**REGULATION No. 37**  
**(Filament lamps)**

**Proposal for Supplement 34 to the 03 series of amendments**

**Submitted by the expert from the Working Party "Brussels 1952" \*/**

Sheet H16/1

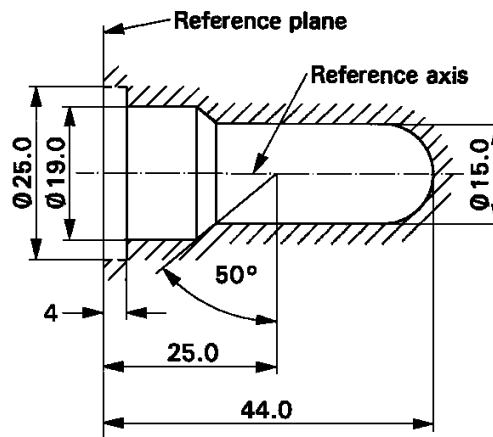
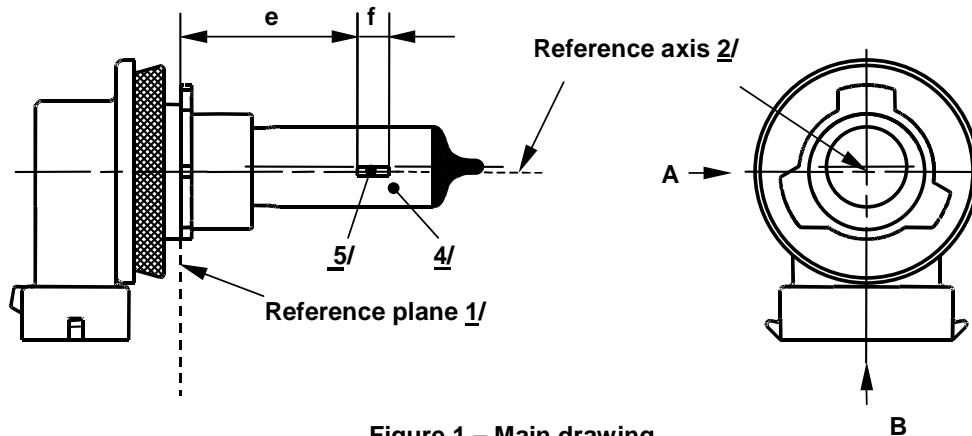
Insert new sheets H16/1 to 4, between sheet H15/5 and H6W/1, to read (see next pages):

- 1/ The reference plane is the plane formed by the underside of the bevelled lead-in flange of the cap.
- 2/ The reference axis is perpendicular to the reference plane and passing through the centre of the 19 mm cap diameter.
- 3/ Glass bulb and supports shall not exceed the envelope as indicated in Figure 2. The envelope is concentric to the reference axis.
- 4/ The light emitted shall be white or selective yellow.
- 5/ Notes concerning the filament diameter.
  - No actual diameter restrictions apply but the objective for future developments is to have  $d_{max.} = 0.9$  mm.
  - For the same manufacturer, the design diameter of standard (étalon) filament lamp and filament lamp of normal production shall be the same.

Figure 4  
Metal free zone 8/

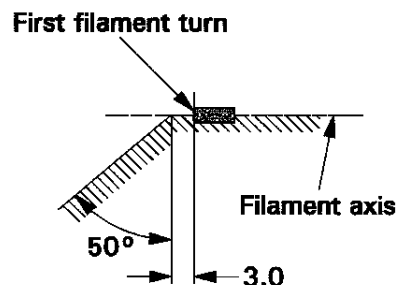
- 8/ The internal design of the lamp shall be such that stray light images and reflections are only located above the filament itself seen from the horizontal direction. (View A as indicated in Figure 1 on sheet H16/1). No metal parts other than filament turns shall be located in the shaded area as seen in Figure 4.

Figure 5

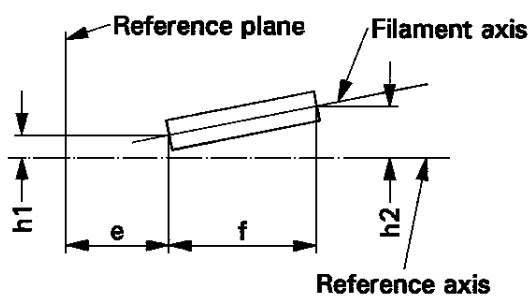
- 9/ The offset of the filament with respect to the reference axis is measured only in viewing directions A and B as shown in Figure 1 in sheet H16/1. The points to be measured are those where the projection of the outside of the end turns nearest to or furthest from the reference plane crosses the filament axis.

Figure 6

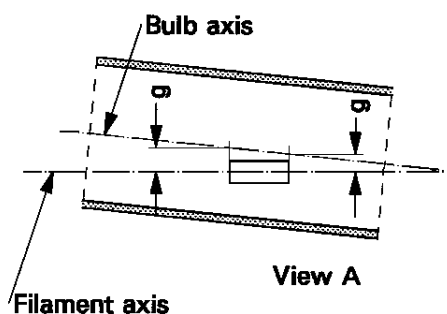
- 10/ Offset of filament in relation to bulb axis measured in two planes parallel to the reference plane where the projection of the outside of the end turns nearest to or furthest from the reference plane crosses the filament axis.

**Sheet H16/3**

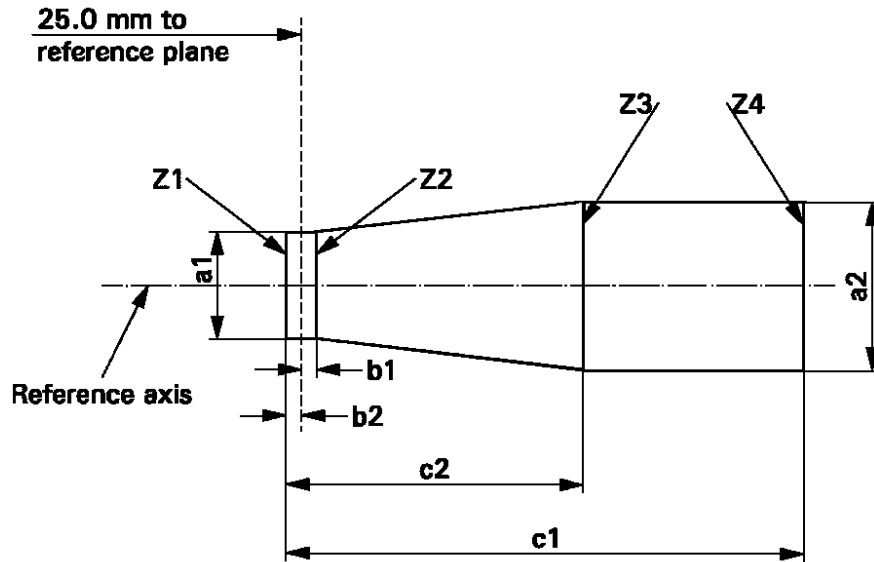
Dimensions in mm		Filaments lamps of normal production		Standard filament lamp
		12 V		12 V
e	11/	25.0	12/	25.0 ± 0.1
f	11/	3.2	12/	3.2 ± 0.1
g		0.5 min.		u.c.
h1		0	12/	0 ± 0.1
h2		0	12/	0 ± 0.15
γ1		50° min.		50° min.
γ2		40° min.		40° min.
γ3		30° min.		30° min.
Cap: H16: PGJ19-3 in accordance with IEC Publication 60061 (sheet 7004-110-2)				
<b>ELECTRICAL AND PHOTOMETRIC CHARACTERISTICS</b>				
Rated values	Volts	12		12
	Watts	19		19
Test voltage	Volts	13.2		13.2
Objective values	Watts	22 max.		22 max.
	Luminous flux	500 +10% / -15 %		
Reference luminous flux: 500 lm at approximately 13.2 V				
Reference luminous flux: 550 lm at approximately 13.5 V

11/ The ends of the filament are defined as the points where, when the viewing direction is direction A as shown in Figure 1 on sheet H16/1, the projection of the outside of the end turns crosses the filament axis.

12/ To be checked by means of a "Box System"; sheet H16/4.
